**From:** Matthew Brewer <matthew.brewer@rpsgroup.com>  
**Sent:** 08 April 2019 17:03  
**To:** Grandfield, Andy <Andy.Grandfield@eastleigh.gov.uk>  
**Cc:** Louise Braine <Louise.Braine@rpsgroup.com>  
**Subject:** RE: GE Hamble

Our Ref: 133255-R2(1)-Addendum  
Natural England Ref: O/18/84191

**Re: GE Aviation, Hamble-le-Rice**

Drawing Title: **INDICATIVE SURFACE WATER DRAINAGE STRATEGY**

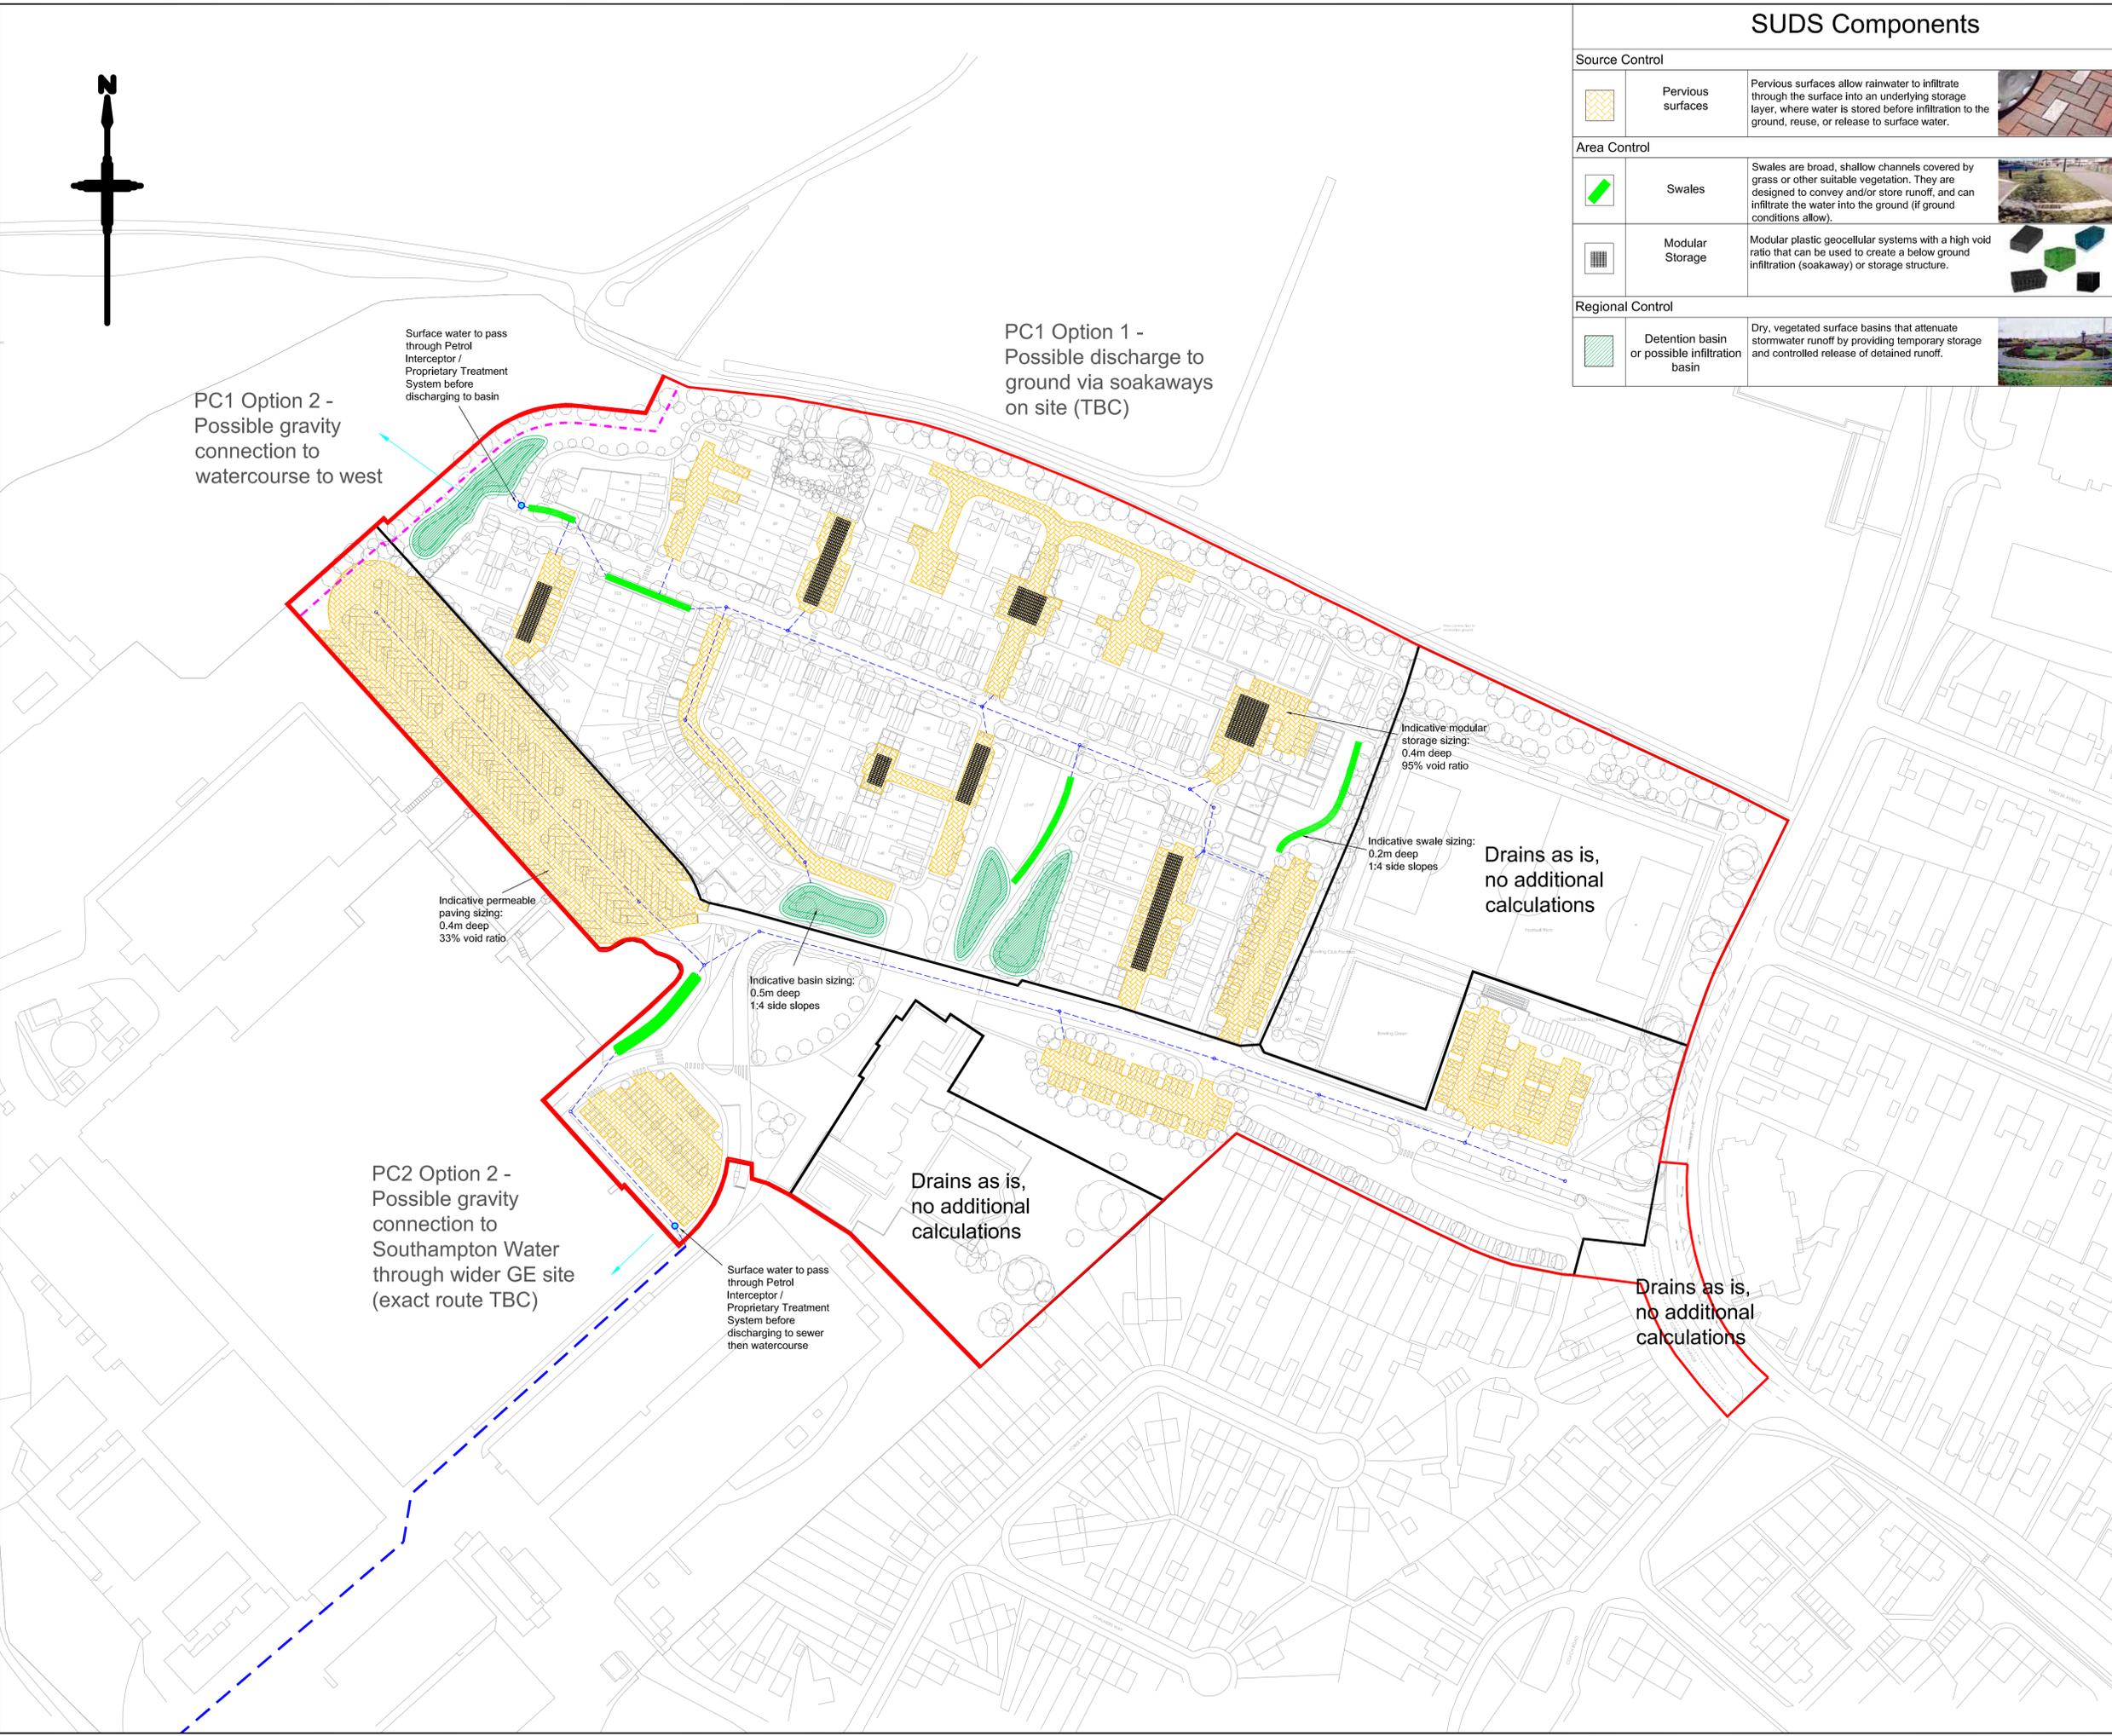
*“Consideration should also be given to potential impacts arising from the proposed surface water drainage strategy. It is noted that a detention basin (or infiltration basin) is proposed along the western boundary adjacent to the ancient woodland. Further detail should be provided that outlines how changes to local hydrology will not impact this site, along with any associated works or infrastructure. If it cannot be ascertained that impacts will be avoided (e.g. through amending the proposed strategy), then measures for mitigation of impacts and compensation for any habitat loss should be outlined in detail.”*

The proposed SuDS for the site include a combination of porous surfaces, modular storage, swales and detention basins. The proposed SuDS features are designed to provide approximately 1,680m<sup>3</sup> of storage in PC1 and 1269m<sup>3</sup> in PC2. This is in excess of the required storage volumes to retain the 1 in 100 plus 40% climate change event on site: 1,406m<sup>3</sup> and 987m<sup>3</sup> for PC1 and PC2 respectively. The SuDS measures are outlined in the Indicative Surface Water Strategy as attached in **Appendix C**.

NE's comment echoes Ancient Woodland Guidance<sup>3</sup> which states that '*development should avoid including sustainable drainage schemes in buffer zones unless they respect root protection areas and any change to the water tables does not adversely affect ancient woodland or ancient and veteran trees*'. The site-specific Tree Report<sup>4</sup> indicates the RPA for the ancient woodland to be 5.4m. As a worst-case scenario, assuming the outermost trees are positioned right up to the boundary, the SuDS features have been offset from the western site boundary in line with this to ensure no impact on the ancient woodland. This SuDS basin location is shown within the Indicative Surface Water Drainage Strategy (**Appendix C**).
